STAFF REPORT

SUBJECT: H-2021-0097
Pine 43 Pad G Drive-Through – CUP

LOCATION: 1492 N. Webb Way, in the NW 1/4 of Section 8, T.3N., R.1E. (Parcel #R7104250566)

Conditional Use Permit (CUP) for a drive-through establishment within 300' of a residential zoning district on 5.31-acres of land in the C-G zoning district.

A. Proposed Site Plan (dated: 10/20/2021)

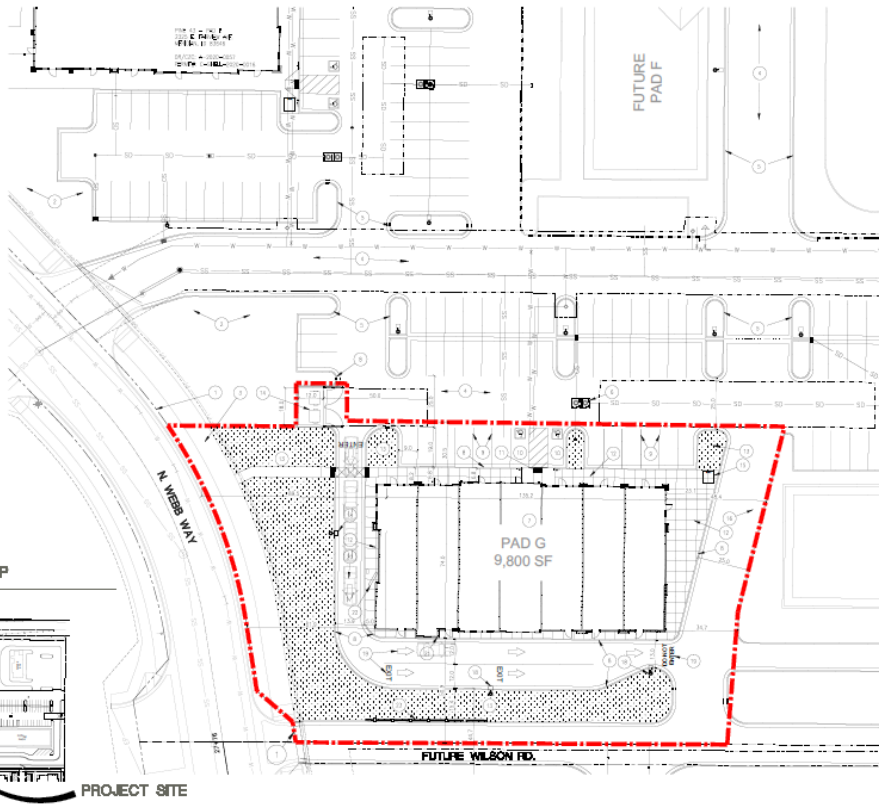
Access: Access is proposed from two (2) future driveways from N. Webb Way along the north and south boundaries of the site. The driveway along the south boundary labeled as future Wilson Rd. is not planned to be extended east of Webb so the name should be removed and it should be constructed as a typical driveway. **A cross-access/ingress-egress easement should be granted to the property to the south for interconnectivity; a recorded copy of the agreement should be submitted prior to issuance of Certificate of Occupancy of the proposed structure.**

Pedestrian Pathways/Sidewalks: The DA requires pedestrian connections to be constructed between buildings in the form of pathways distinguished from vehicular driving surfaces through the use of pavers, colored or scored concrete, or bricks; the site plan should be revised to include these and should also include a pedestrian connection to the future residential development to the south. A minimum 5-foot wide walkway is depicted from the perimeter sidewalk/pathway along N. Webb Way to the main building entrance as set forth in UDC 11-3A-19B.4a.

The stacking lane appears to have capacity for at least seven (7) vehicles and shouldn't obstruct driveways, drive aisles within the site or adjacent public right-of-way.

The stacking lane meets this requirement.

The stacking lane is not located within 10' of any residential district or residence.

The stacking lane exceeds 100' in length and an escape lane is proposed.

The drive-through window is visible from N. Webb Way, a collector street adjacent to the west boundary of the site.

A 6-foot tall sight obscuring fence is required to be provided where a stacking lane or window location adjoins a residential district or an existing residence as set forth in UDC 11-4-3-11D. A 6-foot tall sight obscuring fence is depicted on the site plan as required.

The proposed restaurant is subject to the specific use standards listed in UDC [11-4-3-49](#) Restaurant, which requires at a minimum, one (1) parking space to be provided for every 250 square feet of gross floor area. **The site plan depicts a total of 48 off-street parking spaces in accord with and exceeding this standard; however, most of the parking is depicted outside the boundary of this site. The boundary of the site/future lot should be expanded so that all of the required parking is on this site.**

A minimum one (1) bicycle parking space is required to be provided for every 25 vehicle spaces or portion thereof per UDC [11-3C-6G](#); bicycle parking facilities are required to comply with the location and design standards listed in UDC [11-3C-5C](#). Parking for five (5) bicycles is depicted on the site plan in front of the building. **A detail of the bicycle rack should be depicted on a revised site plan submitted with the Certificate of Zoning Compliance application meeting the aforementioned standards.**

Parking lot landscaping is required to be provided in accord with the standards listed in UDC 11-3B-8C. The landscape plan does not include the entire site. The plan submitted with the Certificate of Zoning Compliance application should depict the entire site and landscaping in accord with UDC standards.

A 25-foot wide buffer to residential uses is required to be provided to the adjacent residential property to the south, landscaped per the standards listed in UDC [11-3B-9C](#). The buffer area is required to be comprised of a mix of evergreen and deciduous trees, shrubs, lawn, or other vegetative groundcover and shall result in a barrier that allows trees to touch within 5 years of planting. A 15-foot wide landscape buffer and 20-foot wide driveway is depicted on the site plan along the southern boundary of the site between the drive-through and future residential uses. With landscaping that provides a dense buffer, Staff is of the opinion the driveway will assist in providing a spatial buffer and does not recommend a wider landscaped buffer is required.

2. The site plan and landscape plan submitted with the Certificate of Zoning Compliance (CZC) application shall be revised as follows:
 - a. If the subject property hasn't been subdivided to create a lot for the proposed development prior to submittal of the CZC application, depict a 20-foot wide street buffer along N. Webb Way landscaped per the standards listed in UDC 11-3B-7C and 11-3B-12C; and a 25-foot wide street buffer along E. Fairview Ave. with a detached 5-foot wide sidewalk, landscaped per the standards listed in UDC 11-3B-7C. *The Developer is required to construct these improvements for the overall 5.31-acre property if this future lot is proposed to develop prior to the final plat being recorded to subdivide the overall property.* The entire site (whatever that is at the time of application for Certificate of Zoning Compliance) shall be depicted on the site and landscape plans.

- b. The boundary of the site/future lot shall be expanded so that all of the required parking is located within the boundary of this site.
 - c. All mechanical equipment on the back of the building and outdoor service and equipment areas shall be incorporated into the overall design of buildings and landscaping so that the visual and acoustic impacts of these functions are fully contained and out of view from adjacent properties and public streets as set forth in UDC [11-3A-12](#).

- d. Depict a detail of the bicycle rack on the plan that demonstrates compliance with the design standards listed in UDC [11-3C-5C](#).
 - e. Depict landscaping within all planter islands within the parking area in accord with the standards listed in UDC 11-3B-8C.

- f. Depict pedestrian connections between the proposed building, future buildings within the overall development and to the future residential development to the south in the form of pathways distinguished from vehicular driving surfaces through the use of pavers, colored or scored concrete, or bricks as set forth in the Development Agreement.

- g. Depict a minimum 5-foot wide walkway from the perimeter sidewalk/pathway along N. Webb Way to the main building entrance as set forth in UDC 11-3A-19B.4a.

- h. Identify the menu and speaker location (if applicable), and window location of the drive-through establishment as set forth in UDC 11-4-3-11B.
3. Future development shall comply with the dimensional standards listed in UDC [Table 11-2B-3](#) for the C-G zoning district.

C. Conceptual Building Elevations (dated: 10/19/21)

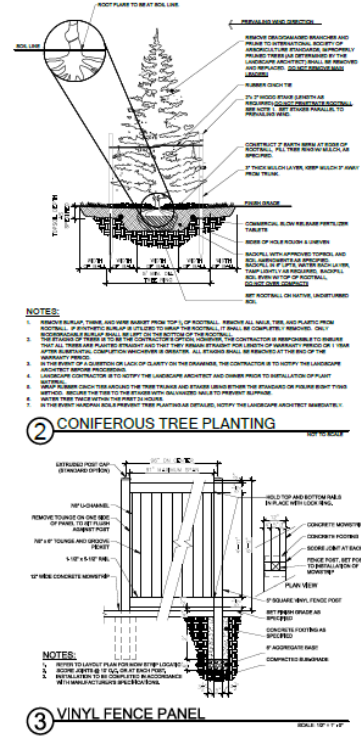
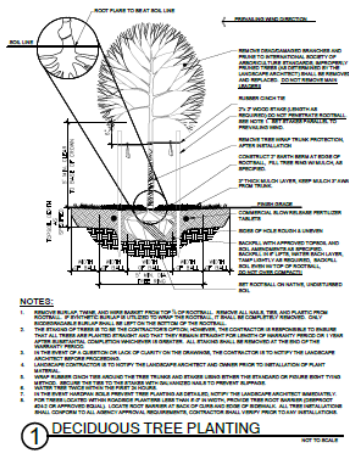
Mechanical Equipment: All mechanical equipment on the back of the building and outdoor service and equipment should be incorporated into the overall design of buildings and landscaping so that the visual and acoustic impacts of these functions are fully contained and out of view from adjacent properties and public streets as set forth in UDC [11-3A-12](#).

Building Elevations: Conceptual building elevations for the proposed single-story structure were submitted as shown in Section VII.C that incorporate a mix of materials consisting of wood siding, corrugated metal siding, stucco, concrete, metal, glazing and stone accents.

The proposed elevations are not approved with this application; final design shall be consistent with the design standards listed in the [Architectural Standards Manual](#) and with the Development Agreement.

9. A Certificate of Zoning Compliance and Design Review application shall be submitted and approved for the proposed use prior to submittal of a building permit application. The design of the site and structure shall comply with the standards listed in UDC 11-3A-19; the design standards listed in the Architectural Standards Manual and with the Development Agreement.
